<b>ELECTRONIC APPLICATION OF KENTUCKY</b>	<b>)</b>	
<b>UTILITIES COMPANY FOR AN ADJUSTMENT</b>	<b>)</b>	
<b>OF ITS ELECTRIC RATES AND APPROVAL OF</b>	<b>)</b>	<b>CASE NO. 2025-00113</b>
<b>CERTAIN REGULATORY AND ACCOUNTING</b>	<b>)</b>	
<b>TREATMENTS</b>	<b>)</b>

**RESPONSE OF**  
**KENTUCKY UTILITIES COMPANY**  
**TO**  
**THE KENTUCKY SOLAR INDUSTRIES ASSOCIATION, INC.'S**  
**SUPPLEMENTAL REQUEST FOR INFORMATION**

**DATED JULY 31, 2025**

#### Question No. 9

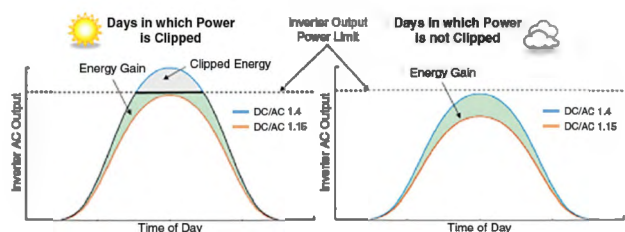
Q-9. Reference: Response to KYSEIA 1-12(c), which states, “a clipped production profile was chosen to maximize the capacity factor for the solar production resulting in the best-case output for solar.”

- Please confirm that a “clipped” production profile reduces the total kWh delivered to the grid.
- Please explain fully how a “clipped” production profile maximizes the capacity factor of solar production and provide an example if possible.

- A solar array with a clipped production profile will in fact produce more energy (kWh) than a solar array sized at 1:1 DC to AC at the same AC nameplate capacity. Higher DC/AC ratios better utilize the inverter as the inverter is more likely to operate near its maximum output during periods of lower sunlight, such as mornings and evenings, or on cloudy days. See diagram provided in response to part b.
- Capacity factor is defined as the ratio of the electrical energy produced by a generating unit for the period of time considered to the electrical energy that could have been produced at continuous full power operation during the same period. Clipped profiles, on systems with higher DC/AC ratios, produce more energy daily, therefore resulting in an increased capacity factor for the generator.

<sup>1</sup> Image source: <https://www.epri.com/research/products/000000003002014245>
